RE: **PETITION NO. 1291** - Eversource Energy petition for a declaratory ruling that no Certificate of Environmental Compatibility and Public Need is required for the Towantic Line Upgrades Project that includes rebuilding and reconductoring approximately 4.4 miles of its existing 115-kilovolt electric transmission lines within existing Eversource right of way between Devon 7R Substation and East Devon Junction both located in the City of Milford, Connecticut; between the West Devon Junction located in the Town of Stratford, Connecticut and Trumbull Junction located in the Town of Trumbull, Connecticut; and between Devon 7R Substation located in the City of Milford, Connecticut and West Devon Junction located in the Town of Stratford, Connecticut and related transmission line structure improvements.

Re: Petition No. 1291
Towantic Line Upgrade Project
Change Location of Access Road at Structure #829

Change Location of Access Road at Structure #829

**TOWANTIC 1710/1730
LINE UPGRADES PROJECT**
FEBRUARY 09, 2017
REVISED: DECEMBER 12, 2017

CITY OF MILFORD (NEW HAVEN COUNTY) AND TOWNS
OF STRATFORD AND TRUMBULL (FAIRFIELD COUNTY), CONNECTICUT
PAGE 14 OF 16

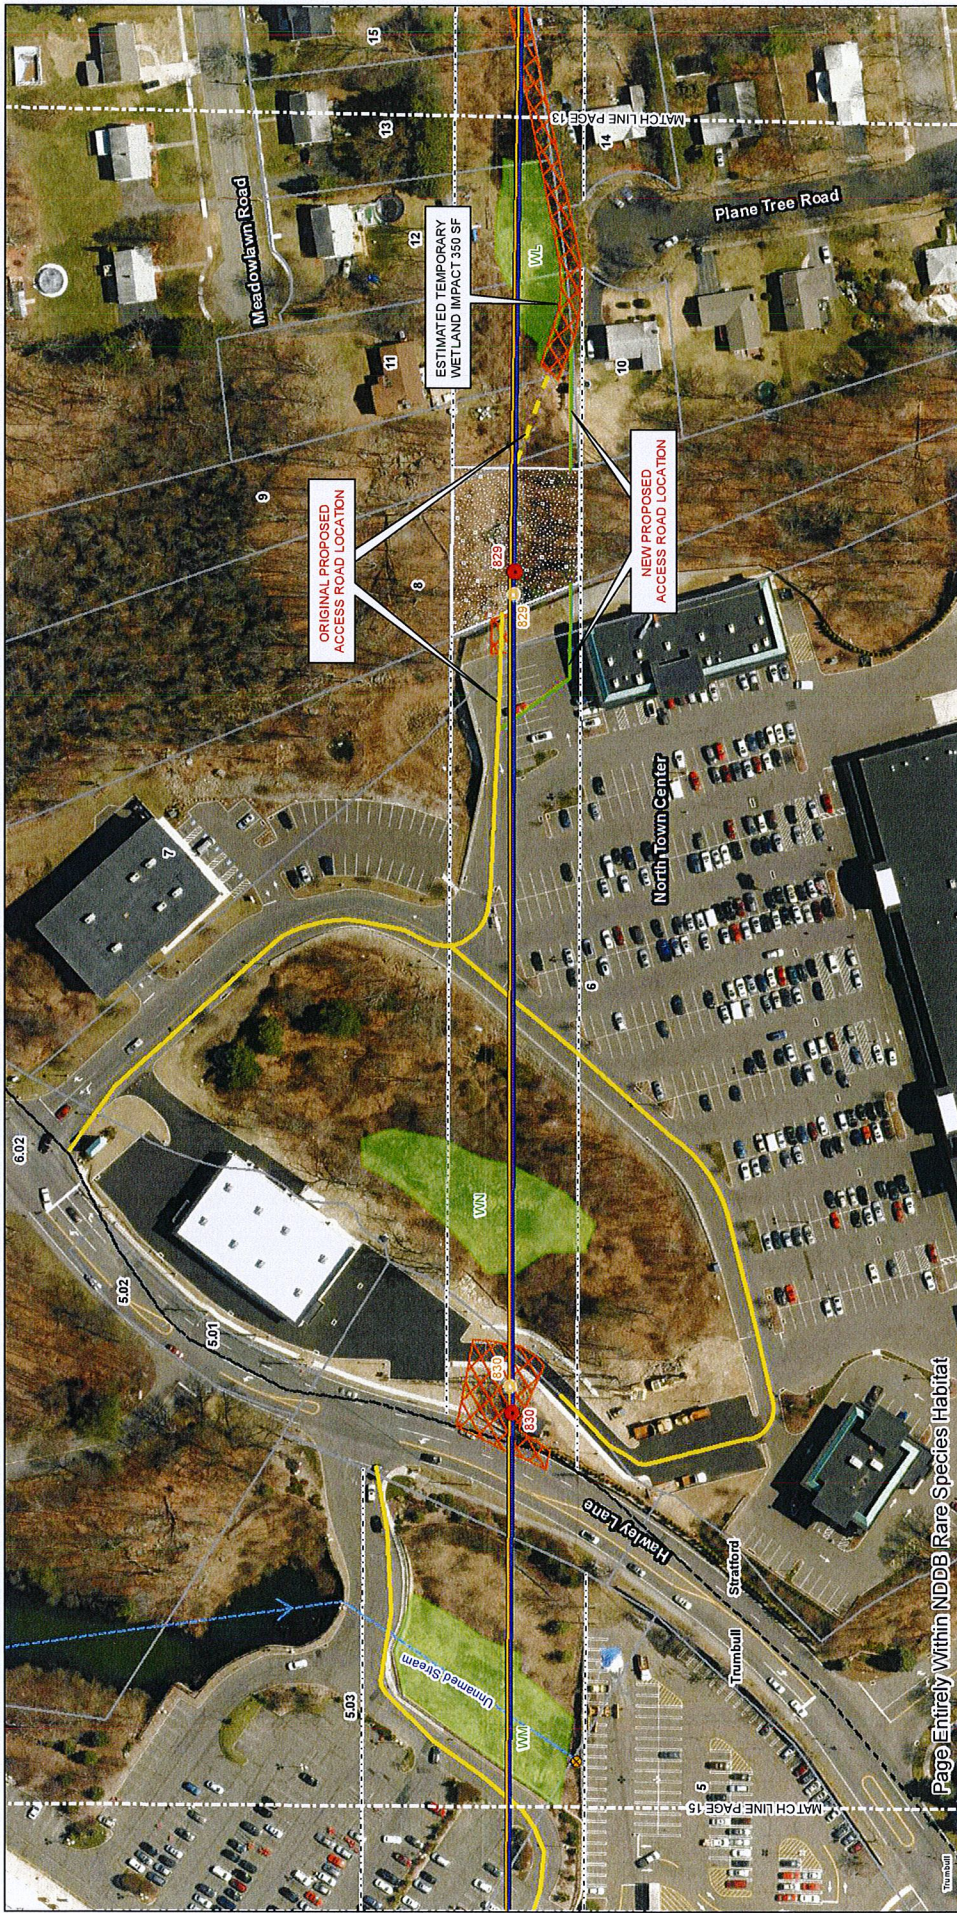
The location of this requested change is at Structure #829 which is situated northeast of the North Town Center in the Town of Stratford and is shown on the attached revised copy of Page 14 of 16 of the mapsheets submitted with the subject Petition (see Attachment A).

Eversource is requesting to shift approximately 100 feet of the proposed access road, located on the east side of the structure’s construction work pad, 50 feet to the south in order to avoid a 12 foot ledge that extends north from the center of the right-of-way (“ROW”). The new proposed access road will utilize an existing grade that is adequate for construction vehicles and will only require minor road improvements (i.e. gravel).

At this time Eversource is also requesting to substitute the use of approximately 150 feet of an existing access road on the west side of the same construction pad with a proposed new access road to be located approximately 50 feet to the south in to provide more space for construction vehicles to access the work pad for this structure.

Pursuant to Condition No. 4 of the Council's Decision on April 27, 2017, your request for the relocation of approximately 100 feet of already approved access road (located on the east side of Structure No. 829) to approximately 50 feet to the south to avoid a 12-foot ledge and the substitution of approximately 150 feet of access road on the west side (of the Structure No. 829 construction pad) with new access road located approximately 50 feet to the south to provide more space for construction vehicles is hereby approved.
